ACCESSORY CONNECTOR

Title		
PRELIMINARY KUPER2001-I ACCESSORY CONNECTOR		
Size	Document Number	Rev
A	q123/456-Re40-92.22-bis	1
Date:	Tuesday, January 08, 2002	Sheet 1 of 1

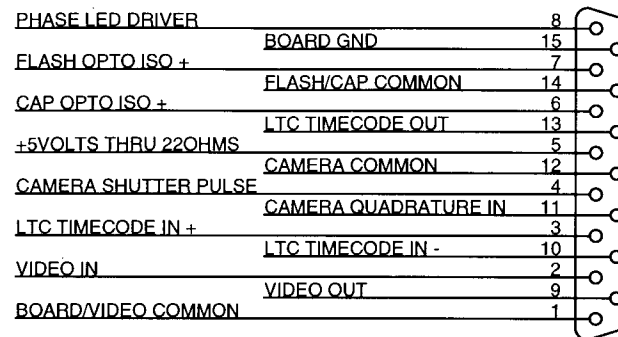
THE FOLLOWING SIGNALS ARE NEW TO THE KUPER2001-I ACCESSORY CONNECTOR. ALTHOUGH THIS SLIGHTLY MODIFIED CONNECTOR SHOULD BE COMPATIBLE WITH MOST ACCESSORY CABLES AND DEVICES BUILT FOR THE OLDER RTMC48 CARD, PLEASE VERIFY THAT THERE ARE NO CONFLICTING SIGNALS PRESENT ON THESE PINS:

- PIN 8, PHASE LED DRIVER
- PIN 9, VIDEO OUT
- PIN 11, CAMERA QUADRATURE IN

**PIN 13 IS NOW LTC TIMECODE OUT. ON THE RTMC48 CARD, PIN 13 WAS THE "CAP-" OPTO ISOLATOR OUTPUT. IT IS IMPORTANT THAT ANY WIRE PREVIOUSLY CONNECTED TO PIN 13 BE MOVED TO SHARE PIN 14.**
